RE: 457 Island Avenue, Peaks Island, ME
Job ID 2011-11-2683-SUBSRF
CBL 090-P-004-001

Please consider this our letter of complaint regarding the building permit issued for the installation of a replacement subsurface wastewater disposal system at the above-referenced property. We allege and aver the following:

SUBSURFACE WASTEWATER DISPOSAL SYSTEM APPLICATION

SUBSURFACE WASTEWATER DISPOSAL PLAN

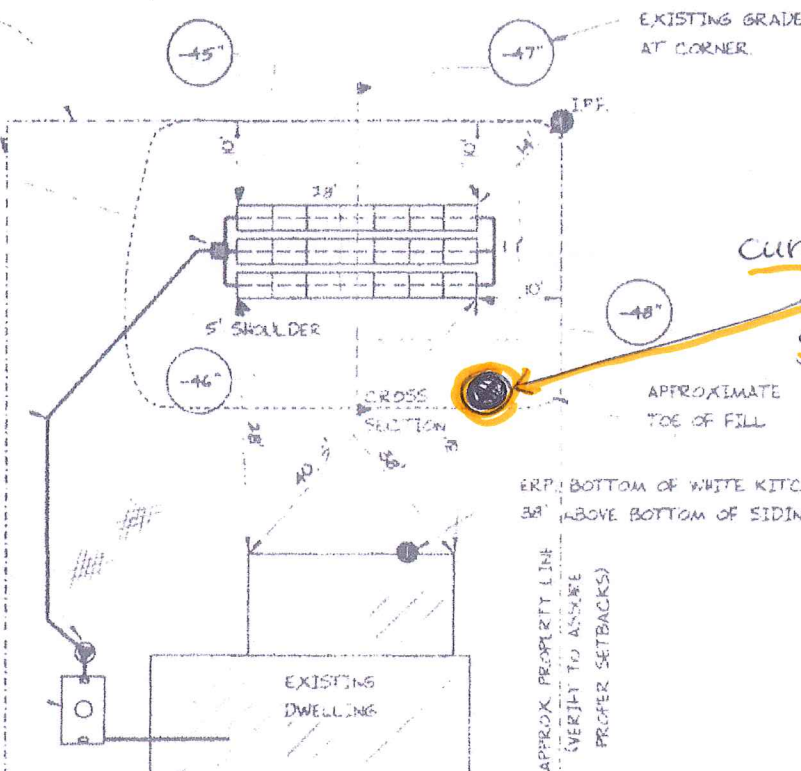
5. The design plan schematic on Page 2 of the application (HHE-200), sets forth that the length of the Smith property from Island Avenue to our property is 99 feet, when, in fact, it is only 98 feet as confirmed in the above-mentioned deed book. Because 99 feet was erroneously used in determining physical placement of all the septic system components, particularly the disposal field, as well as the attendant slope/grade of the land in seeking setback variances, the disposal field and slope encroaches onto our property (50 Sargent Road, Peaks Island) well beyond the 1-foot error and changes the slope/grade of our own property. All of these actions were done without any notice, permission, or agreement from us. Further, at the time of installation to assure proper setbacks, no survey was undertaken to confirm the definitive property lines, wherein Page 3 of form HHE-200 required "approx. property line (verify to assure proper setbacks)."

current location of above ground pump station control box (JB Plugged)
 SJE Rhombus

pump
station
control
box

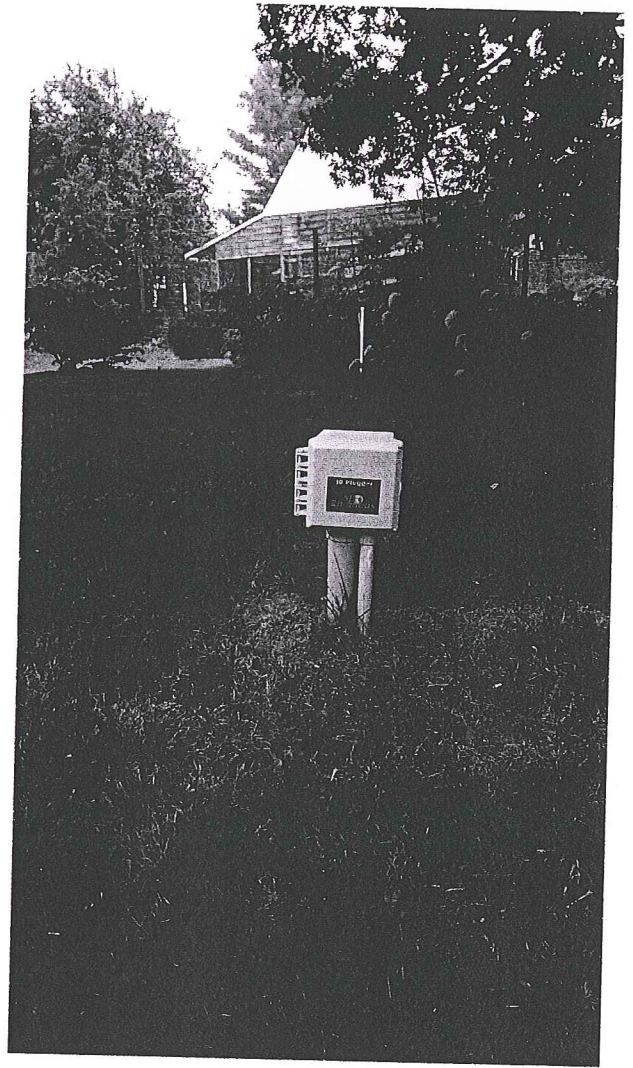
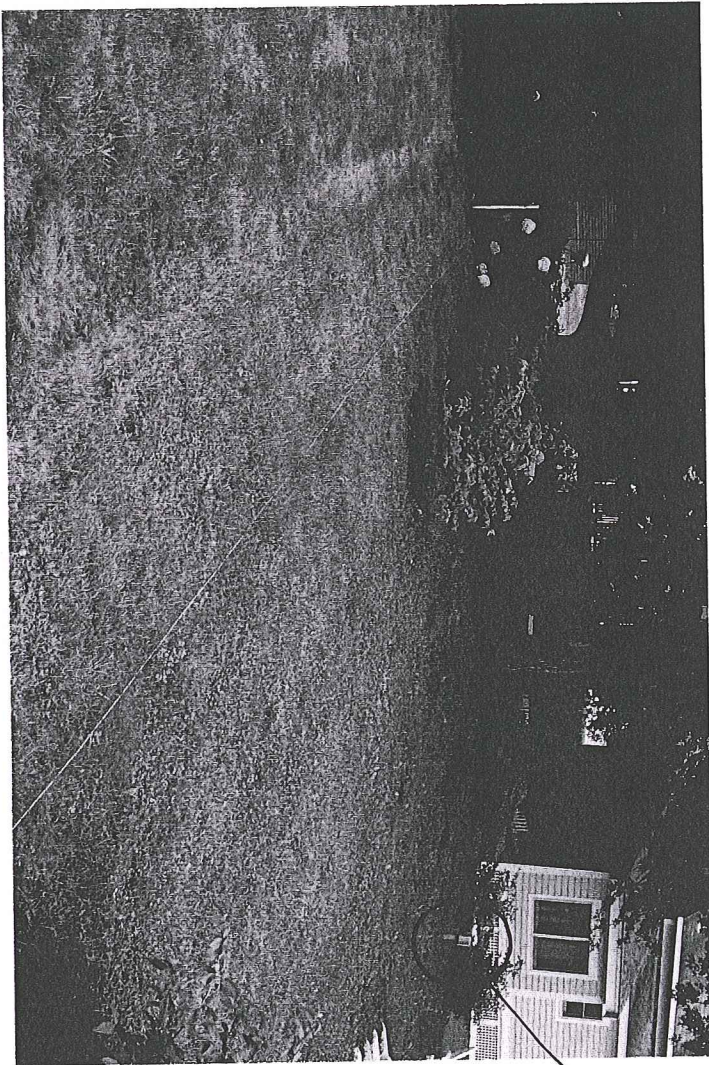
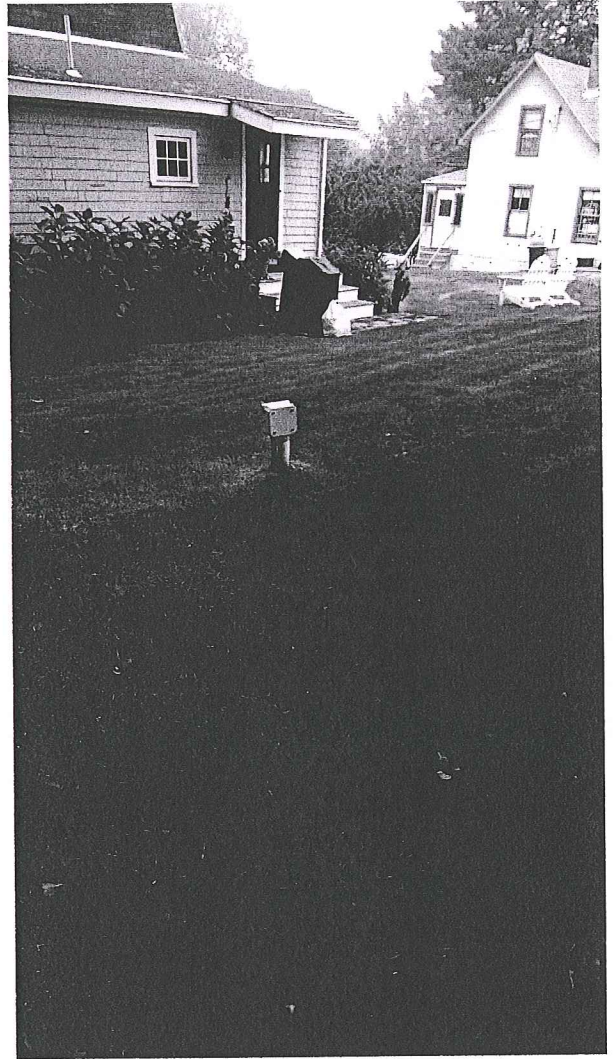
7. On September 6, 2016, a photograph of the relocated pump station control box (JB Plugger/SJE Rhombus) was provided to Portland Code Enforcement Officer Douglas Morin wherein we were informed that "the file was reviewed and that there does not appear to be any violations." By virtue of our complaint, we aver that there are, indeed, violations that warrant further investigation and potential penalty. Please take immediate action and indicate what steps will be taken in response to our complaint. Thank you.
